**Reserved Matters Application including access, layout, landscaping and scale pursuant to Outline Planning Permission 14/02121/OUT for internal Primary and Secondary Streets along with the part discharge of conditions 12, 16, 17 and 19 for Phase 1B at Himley Village, Bicester**

Further to discussions with yourself and Officers at Oxfordshire County Council Highways Department I am submitting a revised scheme pursuant to Reserved Matters application 23/01493/REM for Phase 1B, Himley Village, Bicester.

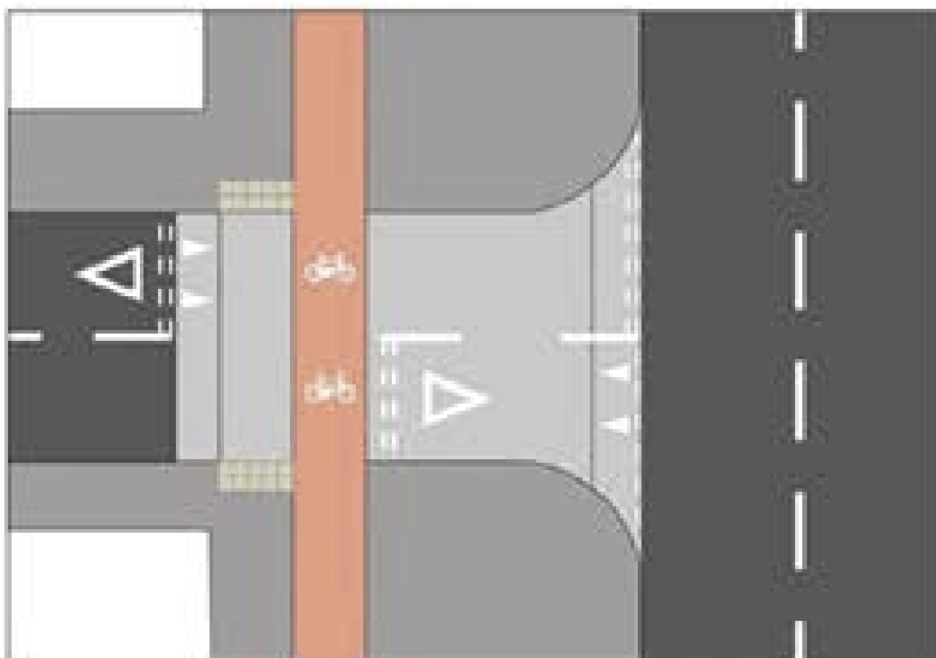
**BBUG Comment 1:**

*"All of the cycle crossings over minor roads require priority access in accordance with Local Transport Note 1/20 (LTN 1/20), OCC's Cycle Design Standards, and the Bicester Local Walking and Cycling*

*Infrastructure Plan (LCWIP). Without priority access, the cycle lanes become essentially useless and most cyclists will either cycle on the main carriageway posing a risk to themselves and an annoyance to motor vehicle drivers.”*

In consultation with OCC Highways (and in agreement with the BBUG comments), the proposed cycle crossing arrangements have been updated to provide priority access to cyclists across the onsite roads. Where crossing points are located adjacent to the main spine roads, the crossings incorporate a 5 metre set back from the main carriageway, lining / signage (to be shown at detailed design stage), tactiles for pedestrians and raised tables / ramps. It is proposed for the priority access over carriageways to be implemented using the principles shown in LTN 1/20, Figure 10.13:

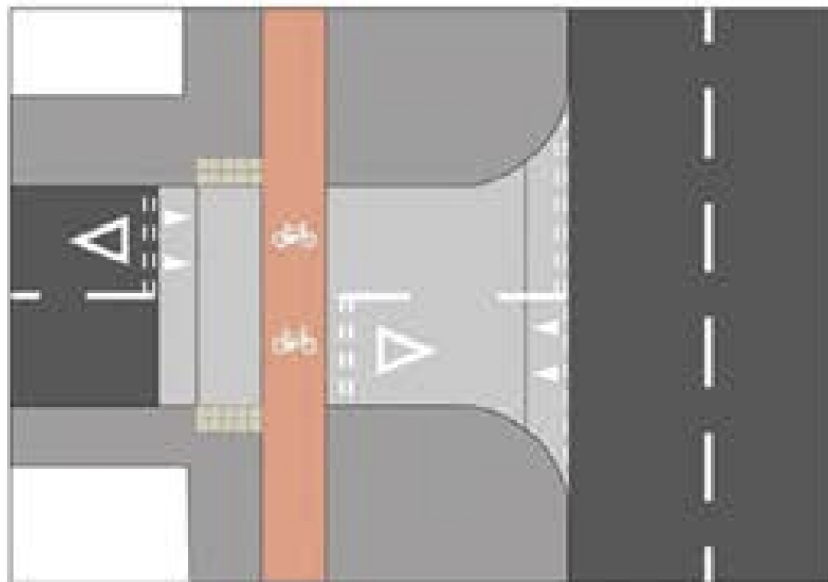
*“The provision of segregated walking and cycling infrastructure on both sides of the Primary Spine Road was previously welcome. However, the revised Phase 1B Infrastructure Reserved Matters Red Line Boundary Plan lacks any obvious treatment at side roads, which will require pedestrians and cycles to give way to vehicles. This will inconvenience / discourage active travel movements. ATE encourages the applicant to adopt approaches set out in either Figure 10.13: Priority crossings of cycle tracks at side roads or Figure 10.15: Full set back, marked priority (bent out) crossing within LTN 1/20.”*

As per the response to the BBUG comment, in consultation with OCC Highways (and in agreement with the ATE and BBUG comments), the proposed cycle crossing arrangements have been updated to provide priority access to cyclists across the onsite roads. Where the crossing points are located adjacent to the main spine roads, the crossings incorporate a 5 metre set back from the main carriageway, lining / signage (to be shown at detailed design stage), tactiles for pedestrians and raised tables / ramps. It is proposed for the priority access over carriageways to be implemented using the principles shown in LTN 1/20, Figure 10.13:
